SERVICE BULLETIN

TS-120S

SUBJECT: TS-120S ANT INPUT TRANSFORMER REPLACEMENT

DATE 8/12/80

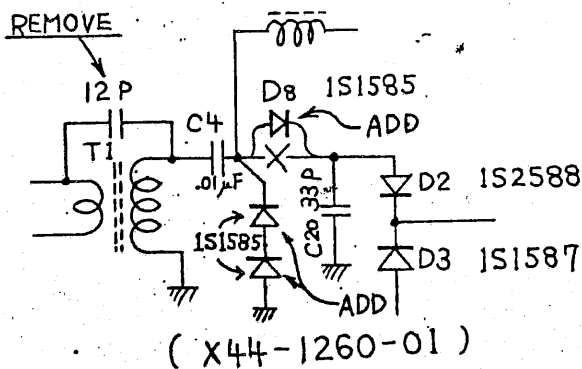
Transceivers subject to strong static fields, high RF, or similar high current atmospheric discharges may suddenly exhibit low sensitivity on all bands. TX will not be affected. Suspect T1 on the RF unit, X44-1260-01.

When replacing T1, L43,0696-35, check that the value of C20 is 33pf. Early units may have a 15pf for C20, and may have T1 as L43-0696-05. In either case, replace the transformer with an L34-0929-15. If C20 is 15pf, replace it with a 33pf capacitor. Since T1 is a broadband transformer, no adjustment is necessary.

In addition, add two 1S1587 diodes after the transformer as shown to further protect the receiver.
